## ELLSWORTH PLACE (FORMERLY CITY PLACE)

### SKETCH PLAN NO. 320240060

Sketch Plan No. 320240060

Item No. 6

Figure 6 – Annotated Public Open Space Exhibit

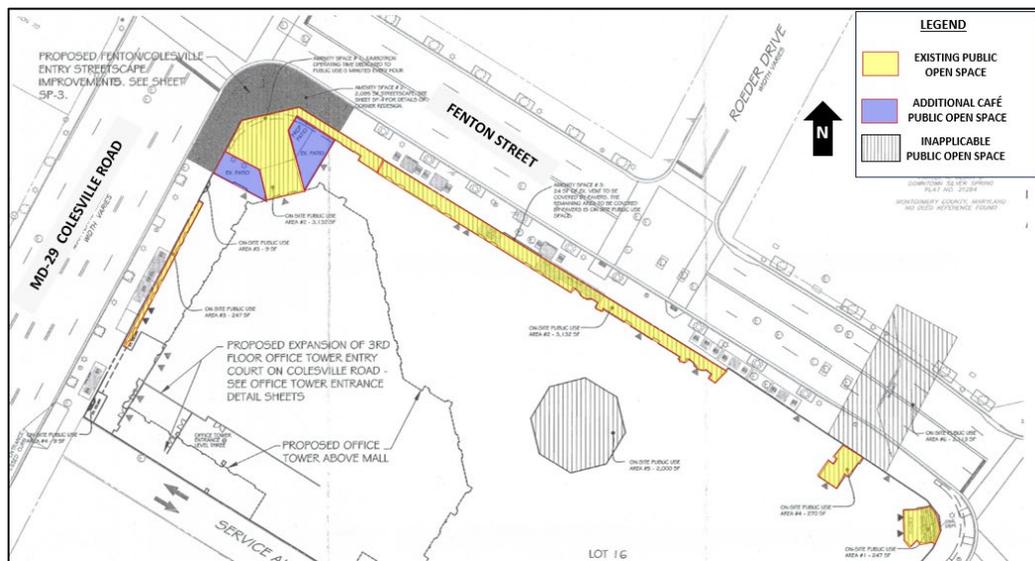
Although the Applicant has provided onsite contribution to previous Public Use Space requirements, not all of the existing areas identified as Public Open Space meet the requirements for Public Open Space in the Zoning Ordinance. Previously, the internal mall atrium and pedestrian bridge, which are both encapsulated by areas of private space, were counted as Public Use Space; per section 6.3.6.B.2 of the Zoning Ordinance, Public Open Space in an optional method development must abut a public sidewalk or other public pedestrian route. Up to 5% of Public Open Space can, however, also include areas designated as café seating; the Applicant has provided approximately 874 sf of outdoor café seating area which was previously not counted. Updating the provided Public Open Space based on this definition clarifies that currently 4,789 sf of qualifying Public Open Space exists onsite; this is depicted in Figure 6 below and provided as Attachment E to this Staff Report.

The remaining area required for Public Open Space, when incorporated into the fee-in-lieu calculation<sup>2</sup> per the Master Plan Implementation Policy, results in a fee of \$358,153.6. As conditioned, this requirement shall be finalized at the time of Site Plan.
